UNITED STATES PATENT AND TRADEMARK OFFICE

10/528,664

Office Action Summary	Application No.		Applicant(s)	
	10/528,664		HEAD, PHILIP	
	Examiner		Art Unit	
	Burton S. Mullins		2834

DETAILED ACTION

Head, Fig.15

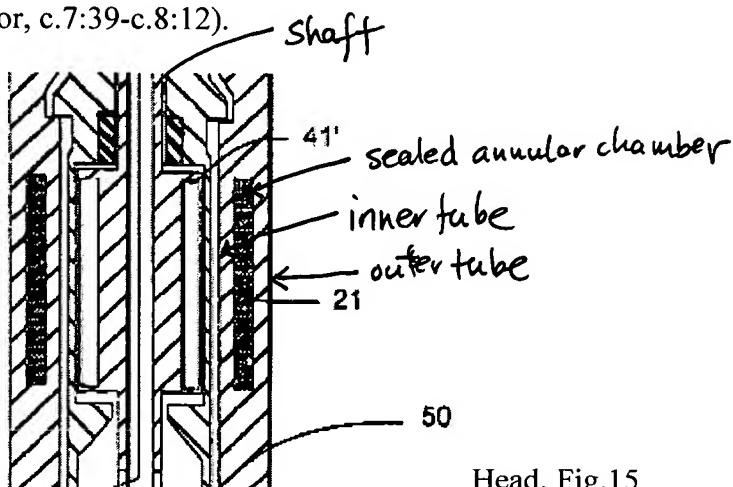
6. Claims 1-8 and 12-14 are rejected under 35 U.S.C. 103(a) as being obvious over Head (US 6,557,642) in view of Mendez (US 5,320,182). Head teaches a brushless dc electric motor for powering downhole tools (Fig.15), the motor comprising: a first stator with conductive windings 21; a shaft (not numbered) centered on and extending along an axis and including a first magnetic element 41' (magnets on rotor circumference); and coaxial inner and outer tubes (not numbered) defining a sealed annular chamber holding the first stators (i.e., stator coil 21), the first magnetic element being aligned with the first stator such that when the winding is energized the stator acts on the magnetic element (i.e., the rotor and stator function as a dc motor, c.7:39-c.8:12).

Head differs only in that the dc permanent magnet motor has only a first stator and rotor, not a second stator and rotor.

It would have been obvious to incorporate plural motors per Mendez into the downhole tool of Head to generate sufficient power to drive the pump to produce a desired flow rate and overcome pressure differentials.

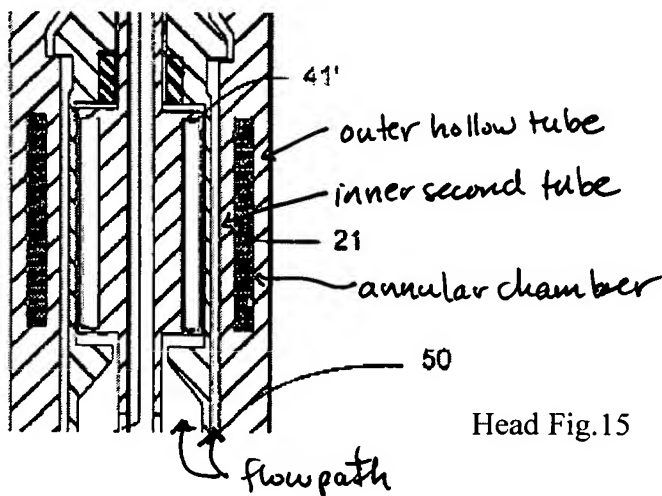
7. Claim 9 is rejected under 35 U.S.C. 103(a) as being unpatentable over Head and Mendez as applied to claim 1 above, and further in view of Luenberger (US 3,135,884). The combination of Head and Mendez does not teach that the second tube is made from a non-magnetizable material.

Luenberger teaches submersible pump motor including an inner tube or sleeve 15 made of plastic such as Teflon disposed within the bore of the lamination stack 2 so as to seal the outer stator (c.1:72-c.2:6).

It would have been obvious to modify Head and Mendez and provide a nonmagnetizable material such as Teflon for the second, inner tube per Luenberger so as to seal the stator.
